# Multimode Fiber Model Issues

From TIA FO-4.1.2

To IEEE 802.3aq

July 2004

# Cambridge Delay Structure Types

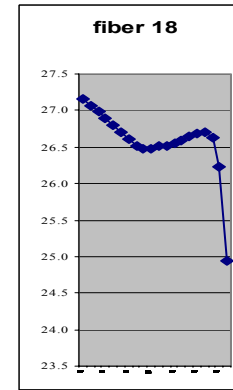
Flat low & mid.  
Poor high order.

Moderate low & mid.  
Poor high order.  
Monotonic.

Moderate low & mid.  
Poor high order.  
Low and high order  
overlap (U shape).

S or Z shape  
(non-monotonic).  
Poor high order.

Variable low order.  
Poor high order.

- DMD magnitude dominated by high order modes, even though these plots ignore two highest mode groups
- Two classes of low order mode behavior for split fundamental mode cases:
  - Leading fundamental followed by alternating higher order delays (e.g. fibers 16, 32, 63)
  - Lagging fundamental followed by non-alternating higher order delays (e.g. fibers 9, 19)

- Extract group delays from these DMD plots
- Include representative delay sets in model if not already present
- Re-examine present core-clad perturbations
  - Magnitude of high order DMD overly dominant
- Scale all delay sets to 500 MHz-km OFL BW without limiting DMD to 2 ps/m
  - Scaling uniformly may not produce delay sets representative of observed fibers
  - Examine other scaling approaches, such as scaling as a function of local index delta

# Some Possible Index Perturbation Deficiencies

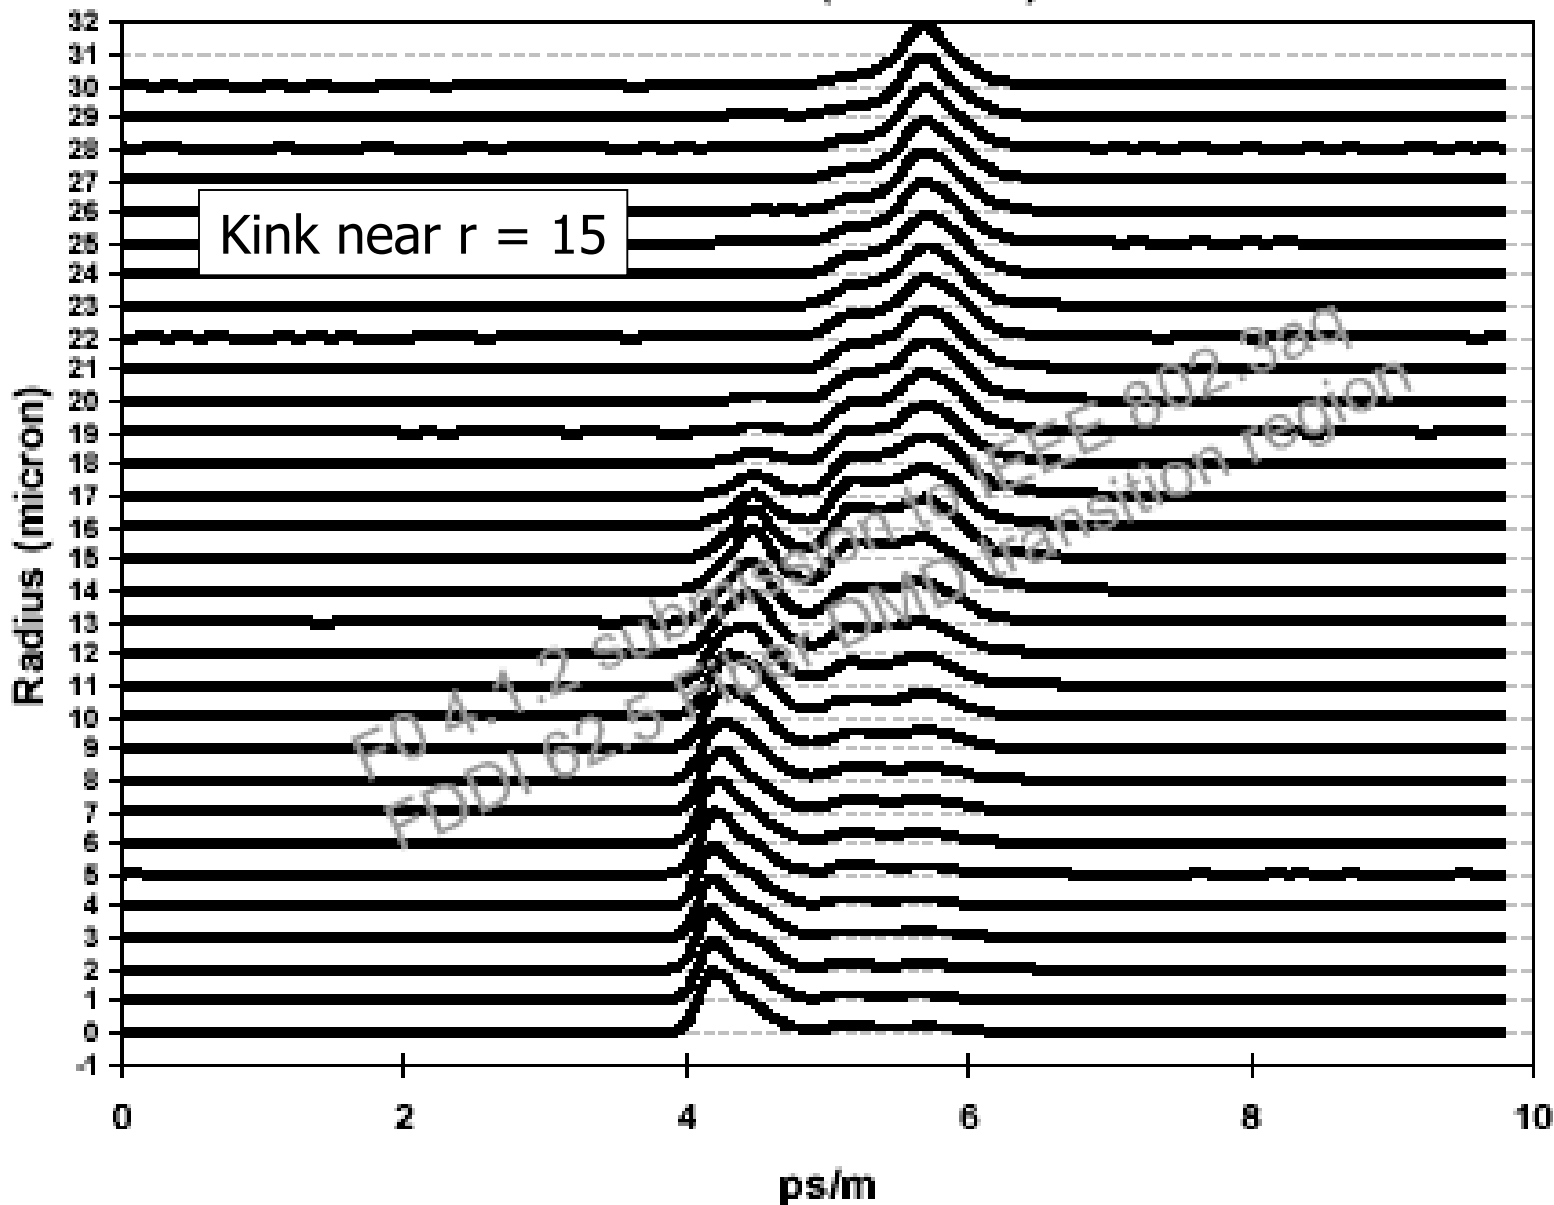
1. variation in the radial width of perturbations at the core center,
2. central perturbation complexity such as index peaks surrounding a dip,
3. central defect in otherwise near-perfect profile,
4. mid-radial  $\alpha$  (power-law) shifts occurring at a variety of radial positions,
5. multiple  $\alpha$  shifts along the mid-radial region,
6. abrupt changes in  $\alpha$  over a very short radial interval (“kinks”) occurring at various mid-radial positions

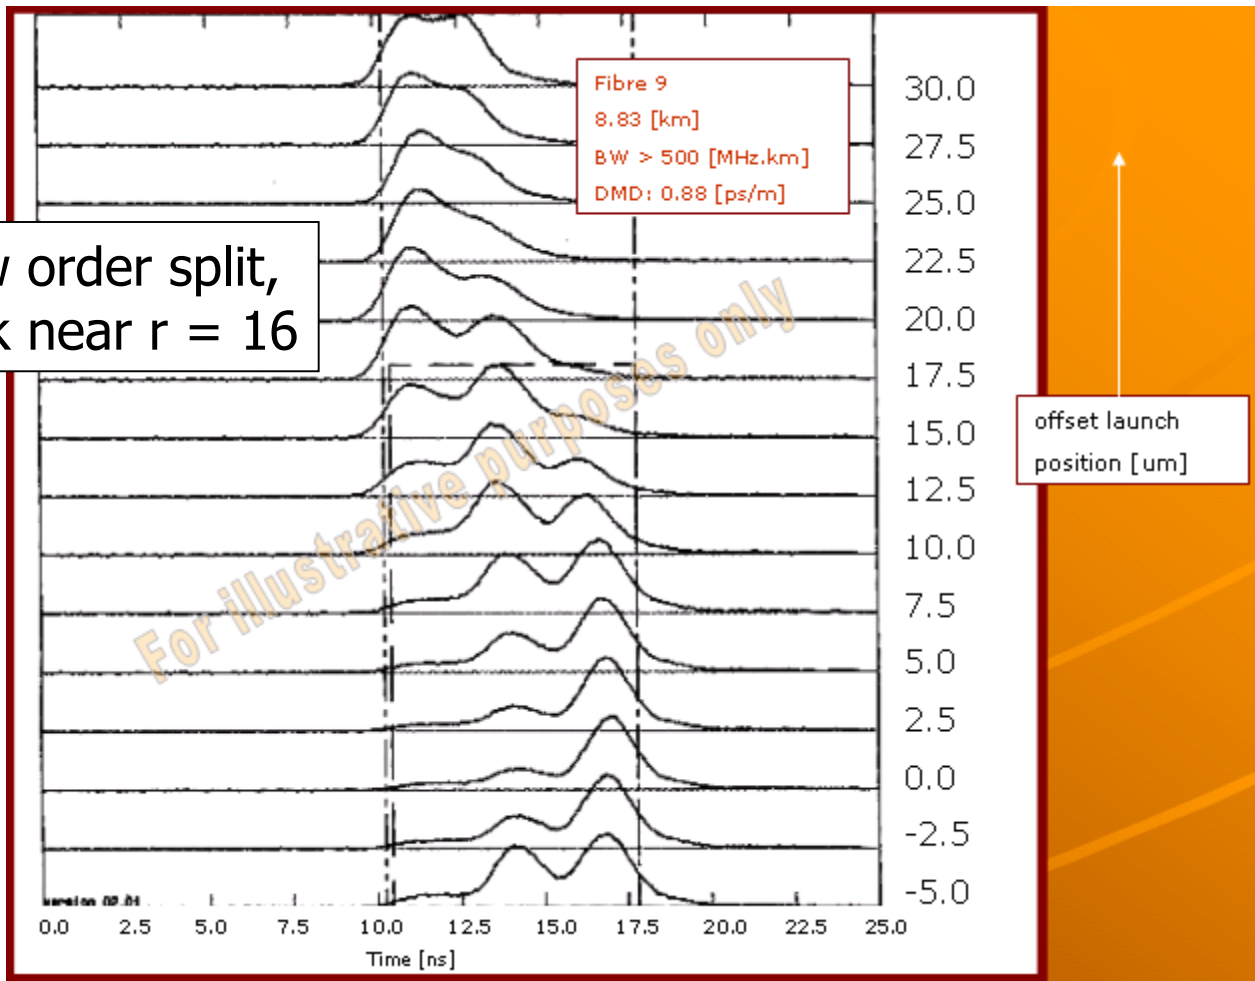
Low order split,  
kink near  $r = 16$
